3.0 Masterplan

3.4 Design Evolution

Design workshops with LBI Officers

Note of design workshop - Mid December 2020

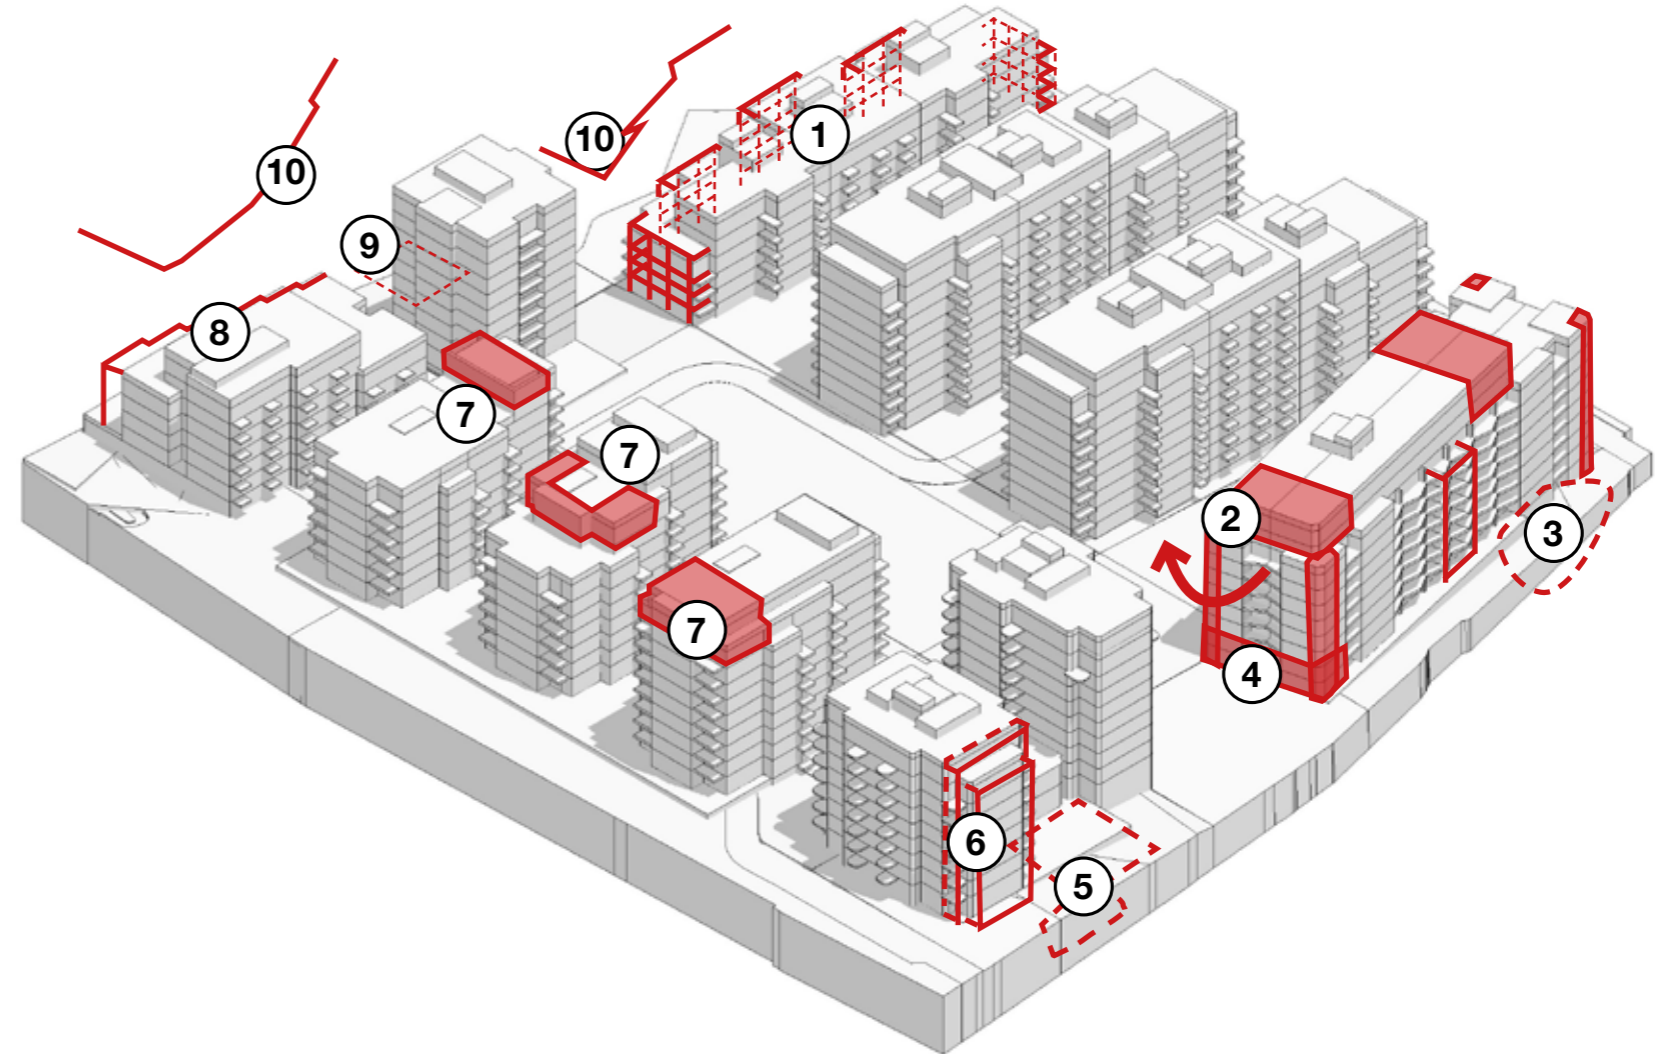
- ① Plot A : Review the architectural character and appearance of northern linear building to be more distinct. Consider ways for the architecture to relate to the Nature Garden opposite.

- ② Reduce mass + Rotate Parkhurst Rd linear building to sit more comfortably between the trees. Additional projections for improved dual aspect.
- ③ Propose to remove existing planter + associated trees and replace with revised landscape set at appropriate levels and new mature trees.

- ④ Propose to include commercial space to prominent corner set back behind colonnade.
- ⑤ New mature trees + new public space at entrance to Women's building

- ⑥ Proposal to extend mass and for the Women's Building to occupy the full ground floor (except resi entrances and a small amount of commercial)
- ⑦ Review the massing to top of Plot D to pull massing away from St. Paul's in LV4B.

- ⑧ Consider the implications for additional steps to the massing for improve aspect. Consider options to improve activation to prominent corner.
- ⑨ Insufficient ground floor space for a Crèche in highlighted location and queried if required at all.

- ⑩ Impact to gardens and windows to be analysed and reported.

Note of design workshop - Late December 2020

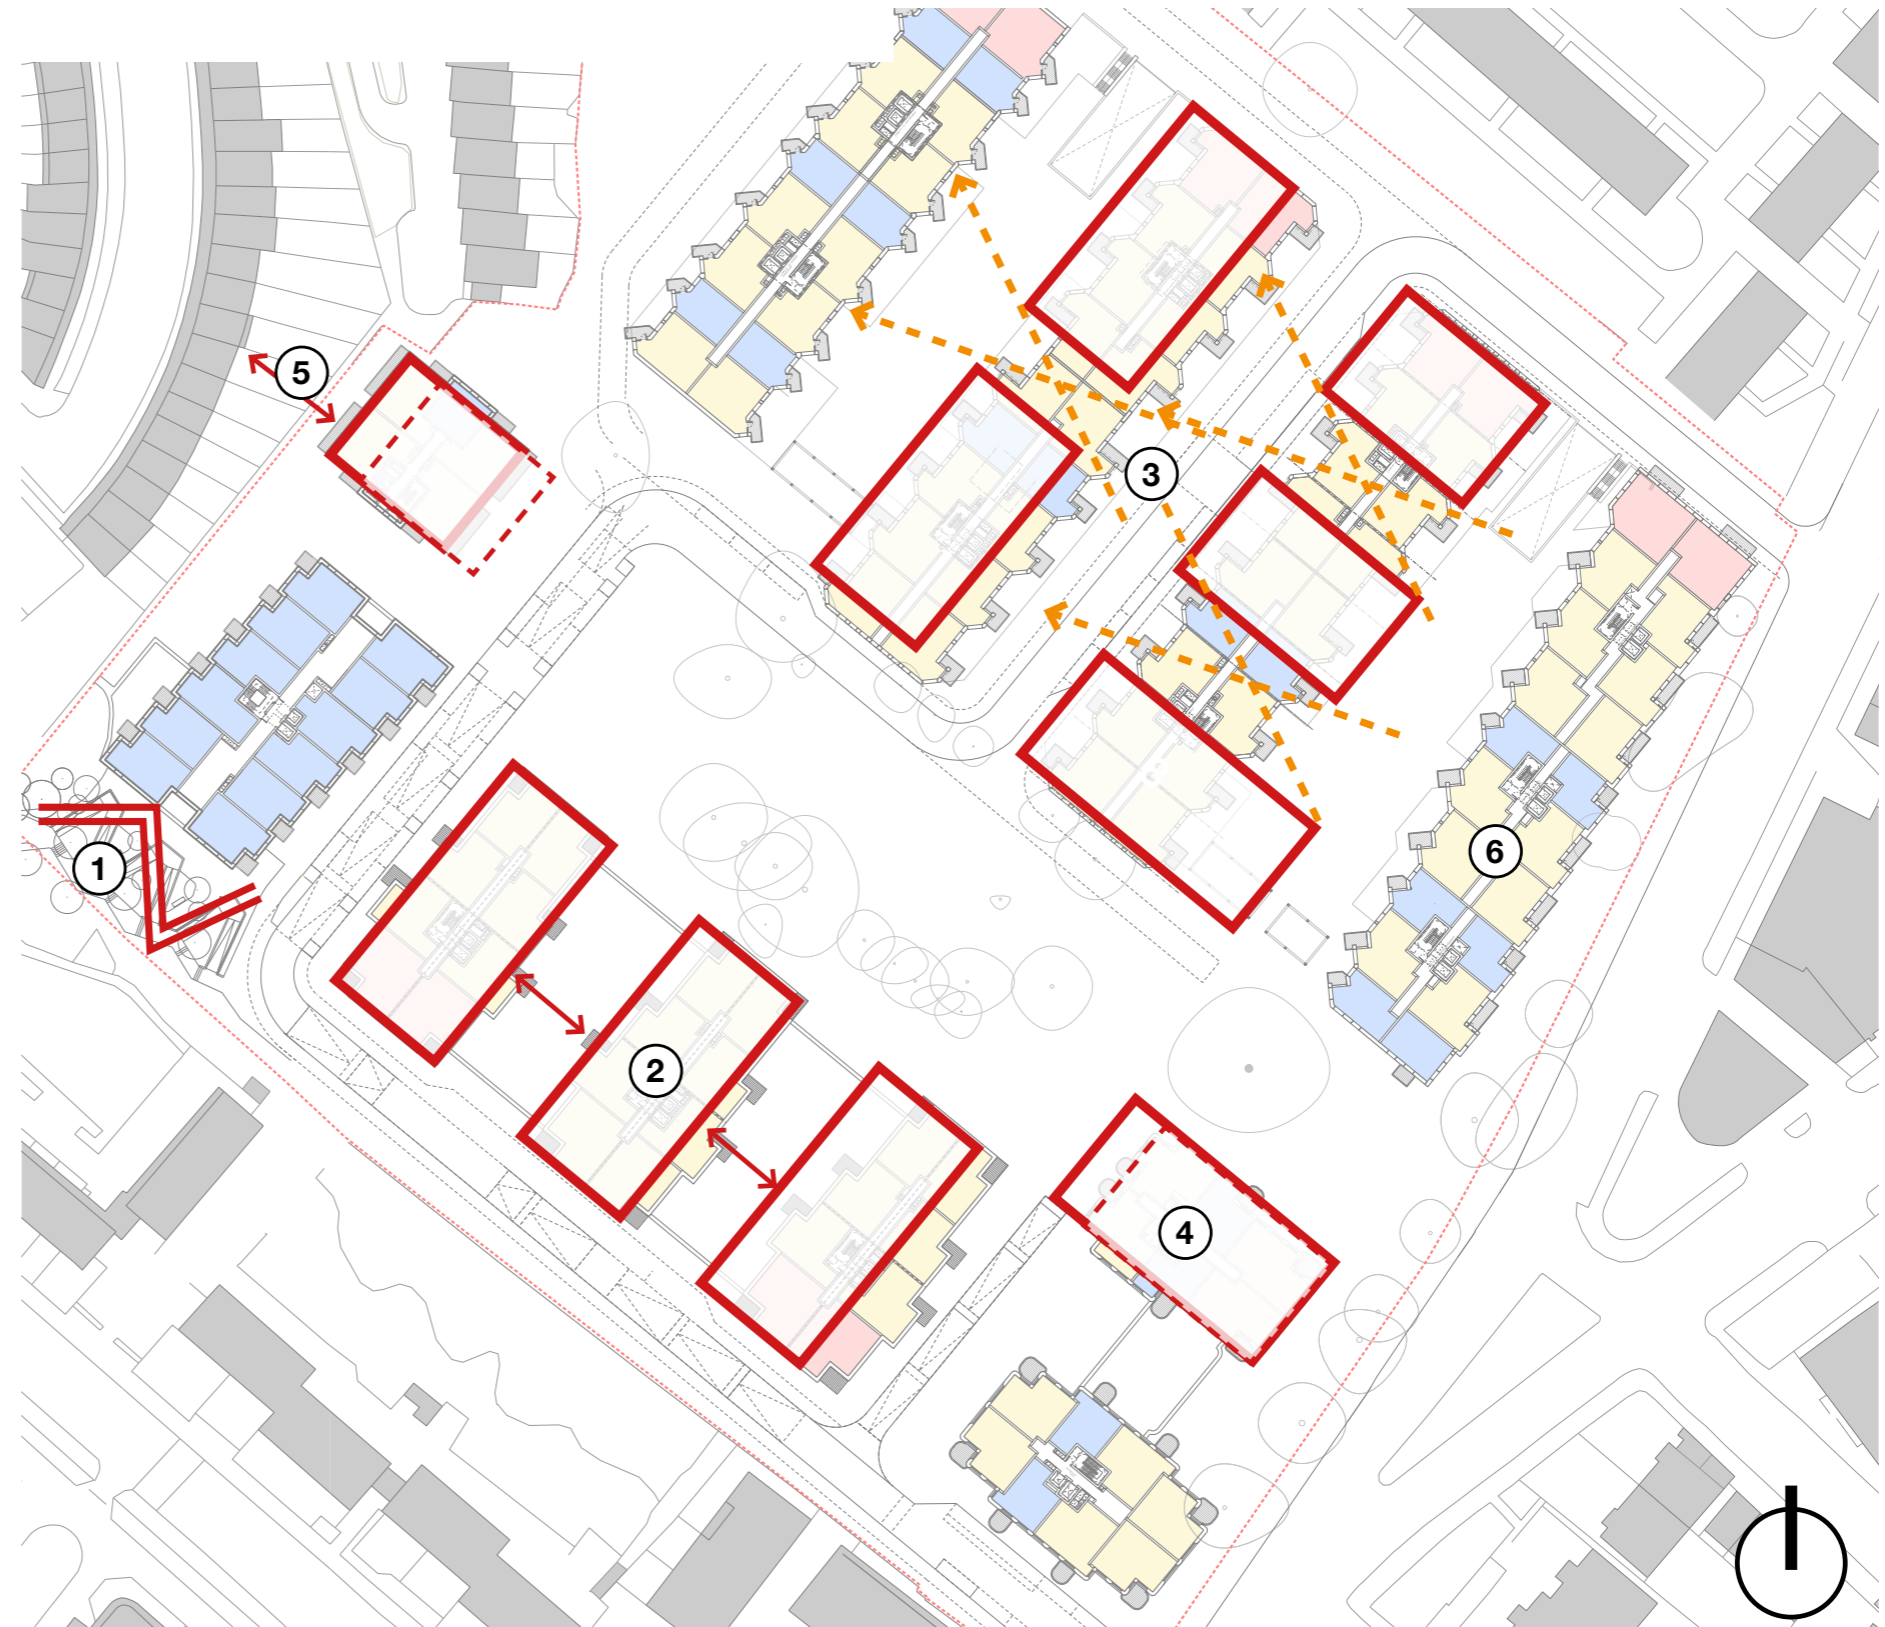
- ① Review the quality of existing trees and consider proposals to retain vs remove with consideration of proximity of adjacent buildings. (Give consideration to the method of construction)

- ②A Review mass to B.2 Parkhurst Road corner re. +30m & design of balconies.
- ②B Review mass to C.2 South corner re. +30m
- ②C Review mass to D.1&2 re. +30m and consider the number of steps in height and clarity of the massing.

- ②D Review mass to E.2 re. +30m and in relation to light to neighbour properties
- ②E Update the area of roof above + 30m in light of the above.
- ③ Consider the implications for additional steps to the massing in relation to light to neighbour properties. Review core position and additional stairs and ensure sufficient corridor width for an enjoyable and accessible journey. Consider the directionality and material quality of the proposed balconies and update the dual aspect figures.

- ④ Review implications of additional massing moves described above for the properties in Bakersfield and Penderyn Way including VSC / NSL / ASHP / Overshadowing to gardens

Note of design workshop - Early June 2021

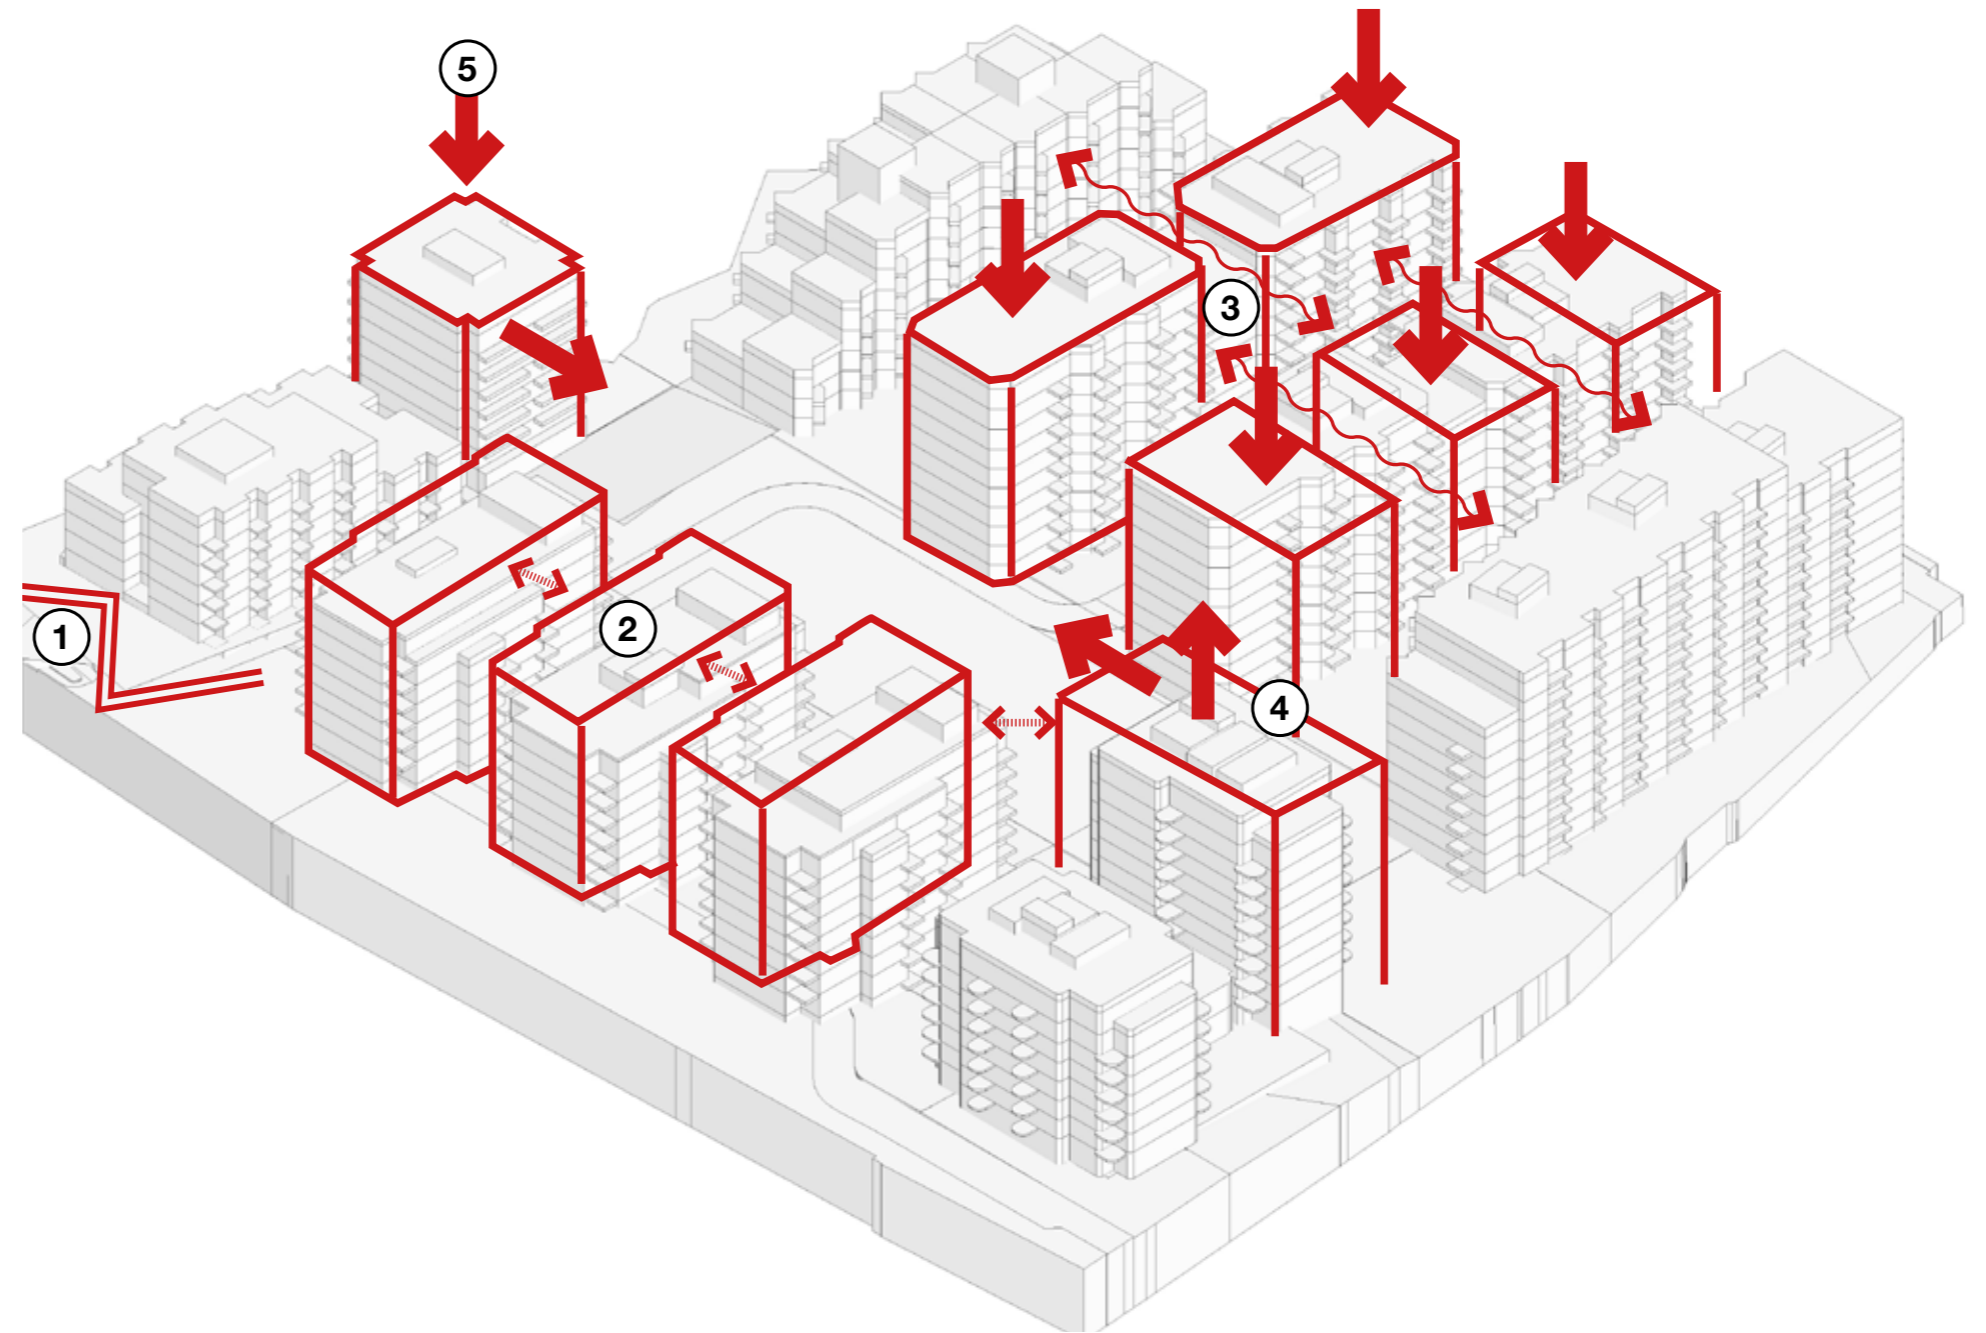
- ① Trescastle connection: Consider options for fewer zigzags
- ② Thin out plot D to gain space for plot C but retain the architectural quality and character of the February scheme proposals
- ③ Further test the splitting of A2+B1, by assessing the massing and ADF. Develop an architectural character and avoid repetitive geometry. Reduce height by 1 storey to 9.
- ④ Consider two approaches for plot C (which gain units) in townscape views and develop the architectural response
- ⑤ Review the relationship between plot E2 + neighbouring properties to establish the balance between overshadowing to Bakersfield and proximity to Penderyn. Consider options to reduce height and re-position.
- ⑥ Translate improvements to ADF on B2 to other buildings and part of ongoing design development.

Note of design workshop - Mid June 2021

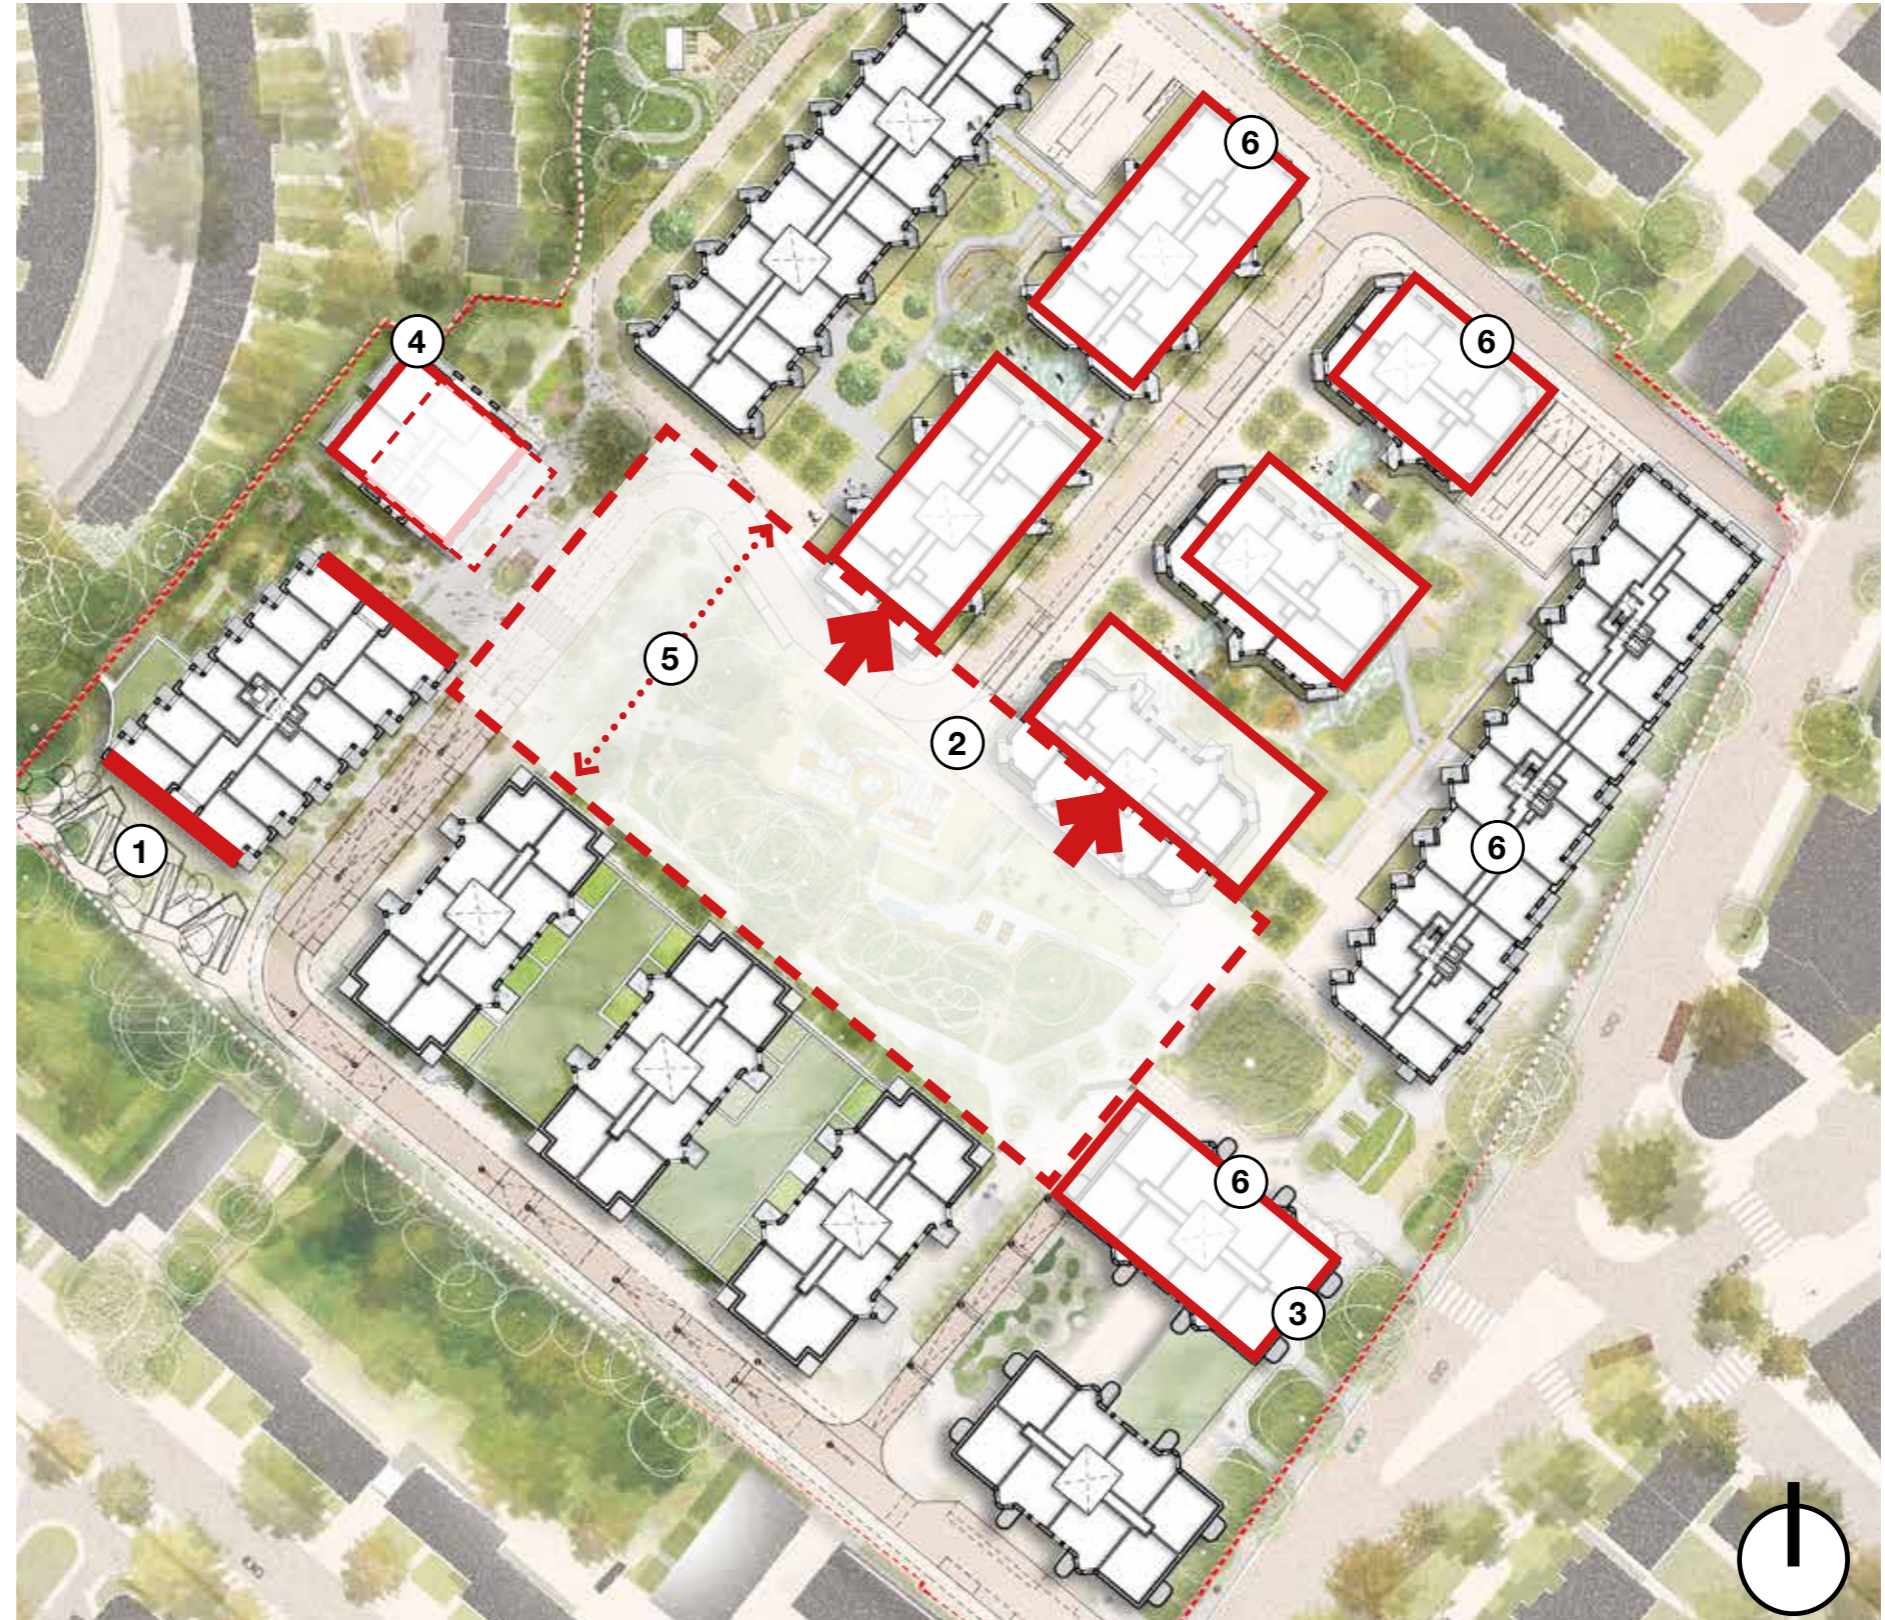
- ① Plot E1+ Trescastle connection: Develop flank elevations to activate route. Max. internal light (Target above 2.0% ADF for LKD)
- ② Max. park area by pushing back the A2+B1 elevation
- ③ Gain some additional area for the Women's building + ancillary accommodation. Review retained and proposed trees to Camden Rd.
- ④ Plot E2 - Push away from boundary and test implications to shadow and internal light. Set out detail of levels + proximity in relation to boundary and neighbours. Demonstrate the improving outlook.
- ⑤ Prepare draft areas for measurement of public / communal / private open space.
- ⑥ PMN: Plot C: Test reduced height to A2+B1 to NE boundary and offset loss with additional height to plot C. Test townscape + others.
